Service Bulletin

PRELIMINARY INFORMATION

Subject: Change Power Steering Fluid to DEXRON®-VI When Replacing Steering Gear Assembly

Models: 2008-2012 Buick Enclave
2009-2012 Chevrolet Traverse
2007-2012 GMC Acadia
2007-2010 Saturn OUTLOOK
Built Prior to July 01, 2011

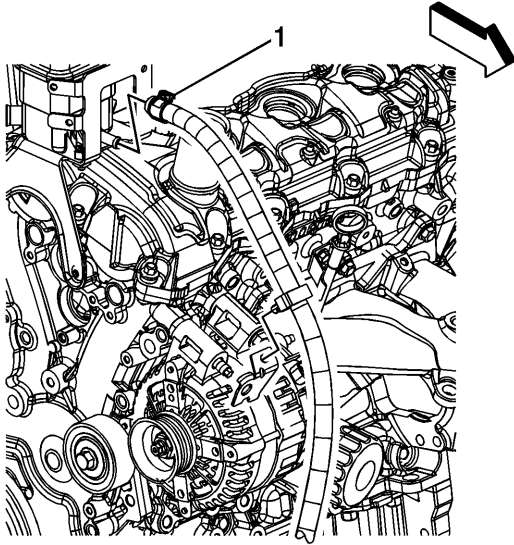
3. Loosen the hose clamp (1) and disconnect the power steering fluid reservoir inlet hose from the power steering fluid reservoir.
4. Plug the power steering fluid reservoir inlet port.
